SERVICE INSTRUCTION

OIL LEAKAGES IN THE AREA OF THE CYLINDER BARREL FOR ROTAX® MOTOR TYPE 912 AND 914 (SERIES)

SI-912-019 R1

SI-914-021 R1

07573

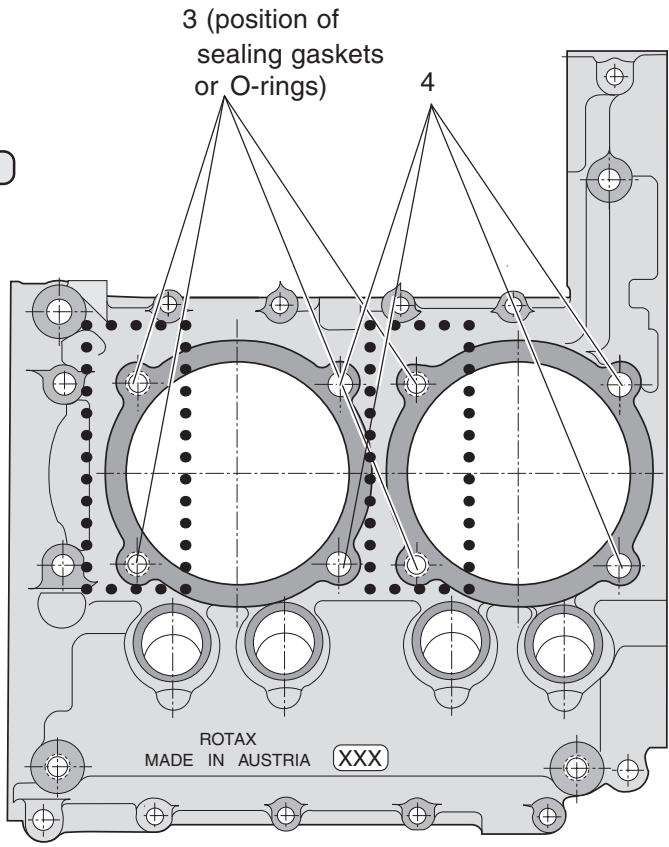
|| Due to standardization and optimization of the operation an optimized thread sleeve has been introduced. In case maintenance work a new O-Ring part no. 431570 is necessary.

Due to deviations during assembly operation, some isolated cases of slight oil leakage in the area of the cylinder barrel have been noted. For repair purposes additional a special gasket was created which seals this area.

- in the area of the cylinder barrel (1)
 - if you notice oil leaks in this area then the following work has to be performed.
- ◆ NOTE: If only a small amount of oil leakage is found, a ferry flight to a maintenance facility is permitted.

- With the position still at TDC pull cylinder away from crankcase about 13 mm (1/2 in.) Do not pull out over piston rings.
 - install studs (7) with thread length of 28 mm (1.10 in.) with sealing gasket (2) into positions (3) with hand tight (3 Nm) (26 in.lb).

- ◆ NOTE: At installation of the studs obey the different thread length. Thread length 20 mm (.79 in.) (5) must point in the direction of the cylinder head.

- ◆ NOTE: Install sealing gaskets only on the 2 left hand studs (3) of each cylinder.
 - install studs (6) with unequal thread length of 20 mm (.79 in.) points in the direction of the cylinder head and the short threads of 15 mm (.59 in.) go into the hex. head inserts (4) with finger tight 3 Nm (26 in.lb) (see fig. 1 and 2).

07574

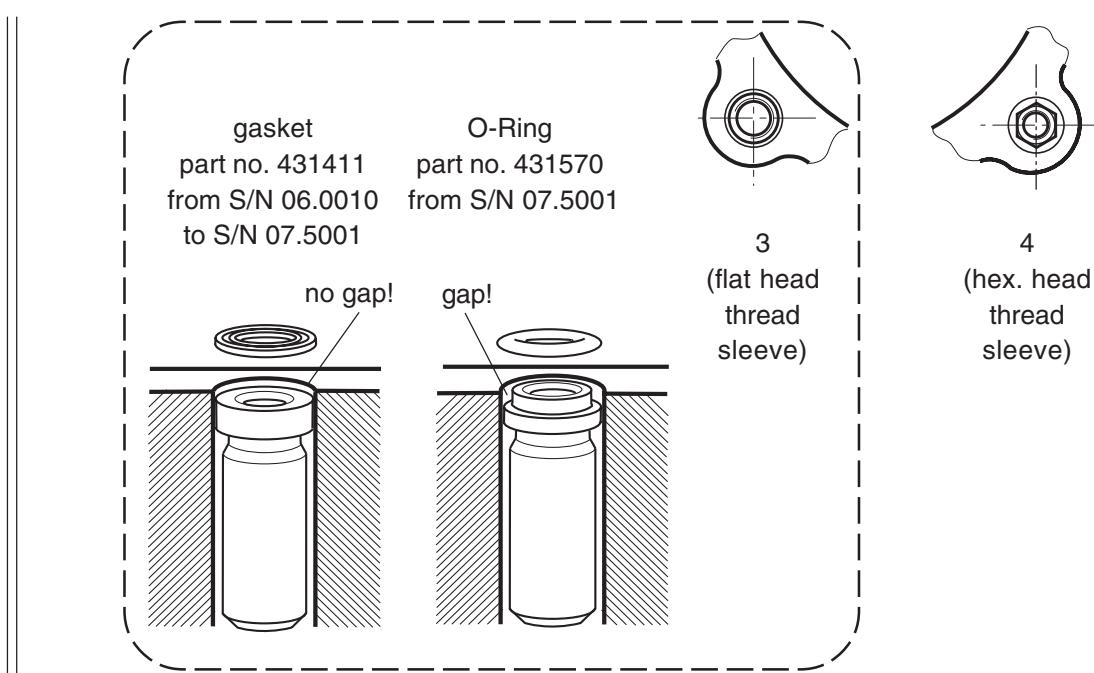
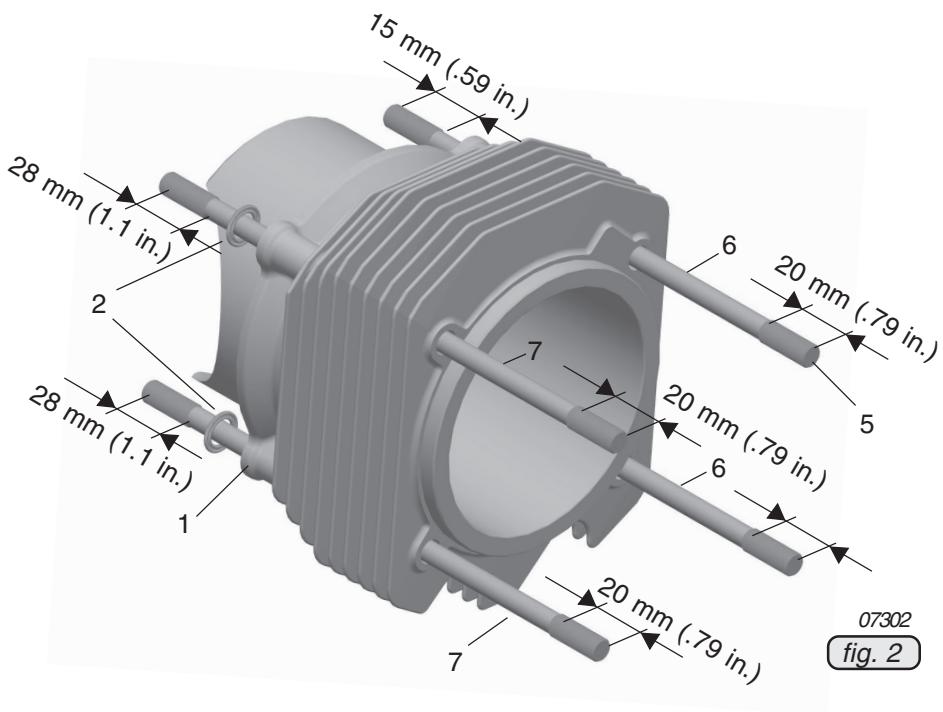
- • • position of sealing gaskets or O-rings on the left hand studs
